**Seventh Quarter Verification Report
Investigation of
Peoples Gas Pipeline Safety Program**

Illinois Commerce Commission

September 27, 2010

III-17

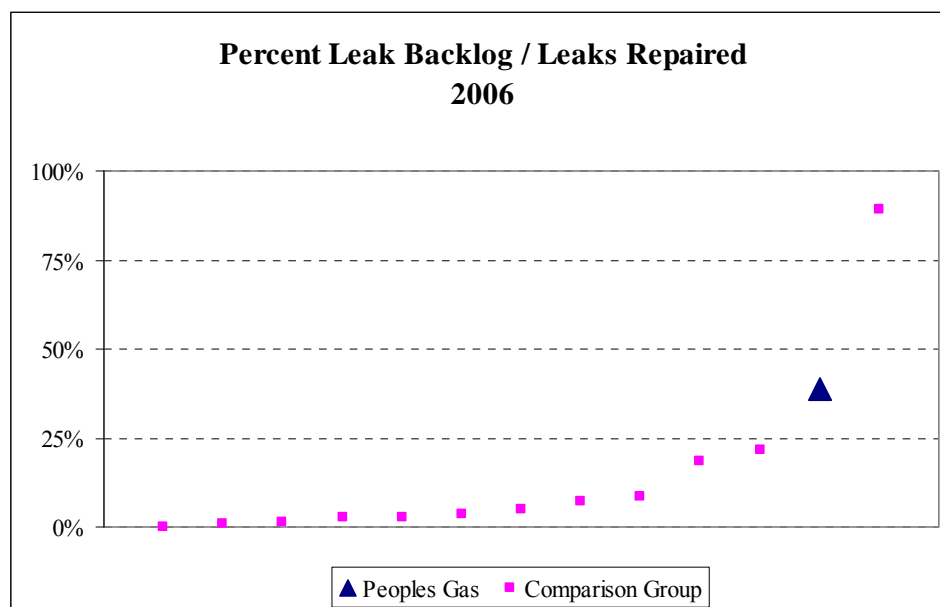
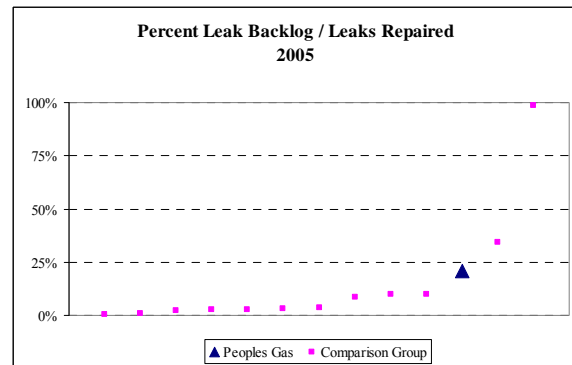
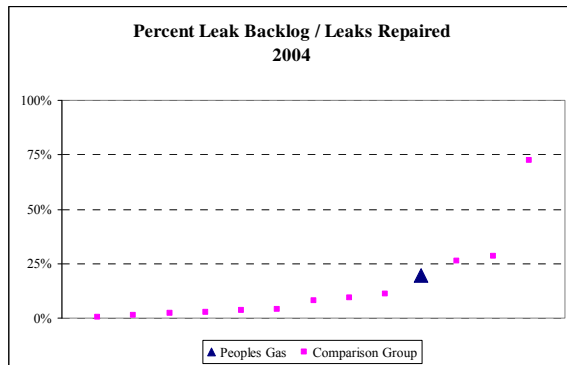
Peoples Gas needs to repair more leaks and reduce the level of backlogs at year-end. In both relative terms, compared to its peers, and absolute numbers of leaks outstanding, Peoples Gas' leak backlog is too high. Peoples Gas should reduce the backlog so that the percentage of the leaks in backlog at year-end is less than 10 percent of the number of leaks repaired during the year. Peoples Gas should develop and implement a written plan for meeting this recommendation. The plan should include specific goals for reducing leak backlogs and repairing more leaks, including target levels for leak backlogs at year-end for the current and following two years.
